Computers and Control Systems: By Symptom

Engine - Hard Cold Starts/Hesitation/Stalls On Start-Up

91-25-7

- ^ HARD COLD START - DURING INITIAL START-UP, IDLE OR DECEL - EFI ENGINES - SLUDGE IN THROTTLE BODY AND/OR IDLE AIR BY-PASS VALVE
- ^ HESITATION/STALLS - DURING INITIAL START-UP, IDLE OR DECEL - EFI ENGINES - SLUDGE IN THROTTLE BODY AND/OR IDLE AIR BY-PASS VALVE

Figure 2

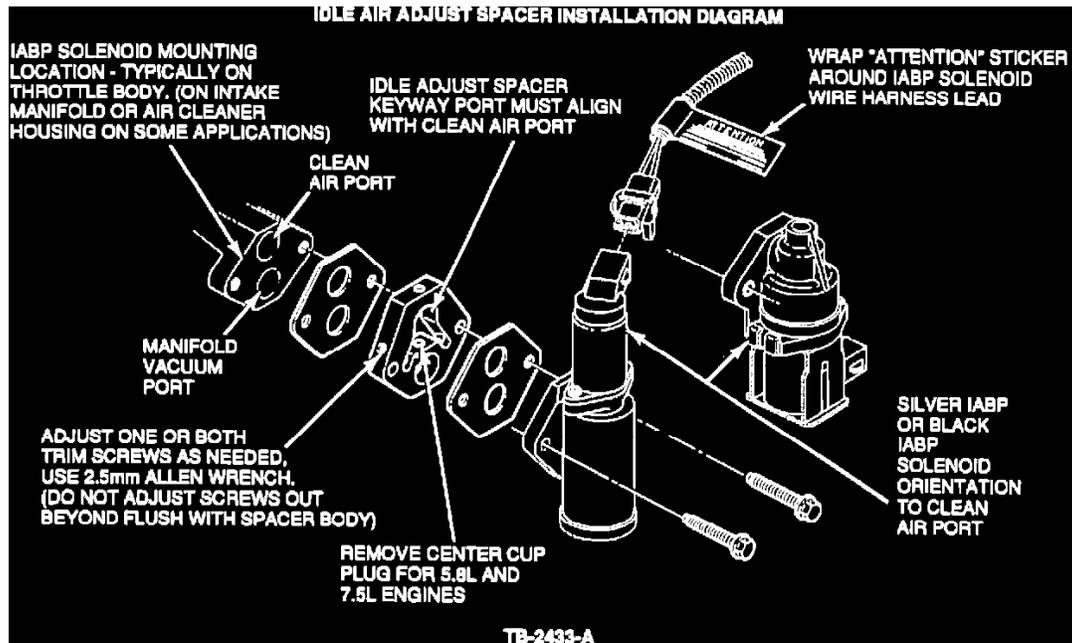
Refer to Figure 2 for a pictorial of the kits components.

The idle air adjust spacer incorporates sludge tolerant design features that eliminate throttle body sludge related conditions. Once installed, throttle body cleaning is not allowed and periodic adjustment of the throttle body is not required.
